PROJECT COMMENTS

PROJECT NUMBER: P2020-046
PROJECT NAME: Preliminary Plat for Gideon Grove Phase 2
SITE ADDRESS/LOCATIONS:

10/21/2020: P2020-046; Preliminary Plat for the Gideon Grove, Phase 2 Addition
Please address the following comments (M= Mandatory Comments; I = Informational Comments)

GIDEON
ROCKWALL
PHASE 2

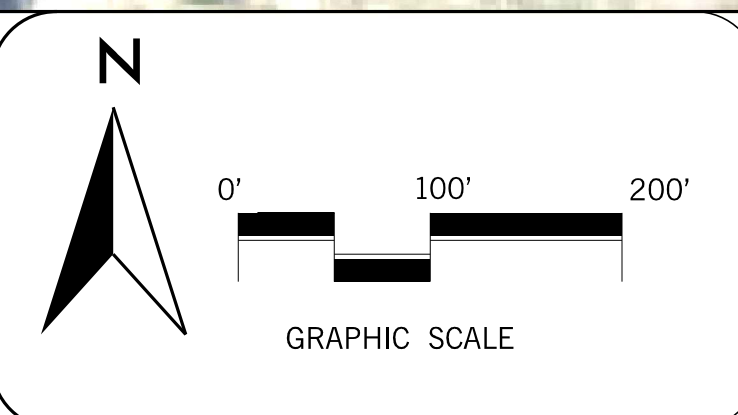
Min 57.5' radius

Must include a 10' utility easement along all street frontage.

No Median opening will be allowed for Street E

Must build E Quail Run Road (four lane divided roadway, 85' ROW width)

Must have a WoTUS determination for both existing ponds.

Add note to sheet, "drainage/detention and open spaces are to be maintained by the property owner/HOA."
